Product Change Notification (PCN)

PCN Number: PCN_ConUMRF_20260918 Affected Series: WR-UMRF Affected Part Number: See table below PCN Date: 2026-06-18 (YYYY-MM-DD) Effective Date: 2026-09-18 (YYYY-MM-DD)	Change Category: ☐ Equipment/Location ☐ General Data ☐ Material ☐ Process ☐ Product Design ☒ Shipping/Packaging ☐ Supplier ☐ Software
Contact: Product Management Phone: +49 (0) 7942 - 945 5001 Fax: +49 (0) 7942 - 945 5179 E-Mail: pcn.eican@we-online.com	Datasheet Change: ☐ Yes ☒ No Attachment: ☐ Yes ☒ No

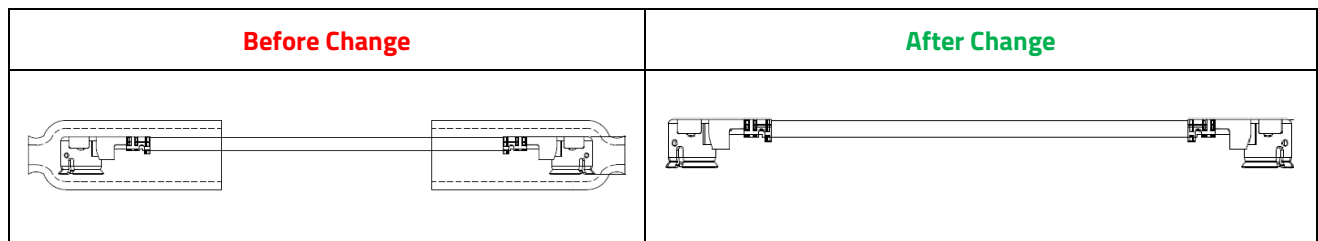
Due to an improvement of the production capability, Würth Elektronik eiSos will remove the protective end caps from the product packaging.

The protective end caps were previously used as an additional packaging protection feature. Based on customer feedback and internal process optimization, they will be removed. Product protection during transportation remains ensured by bubble wrap before packing into the PE bag.

Remove the protective tube on both ends of the UMRF plugs.
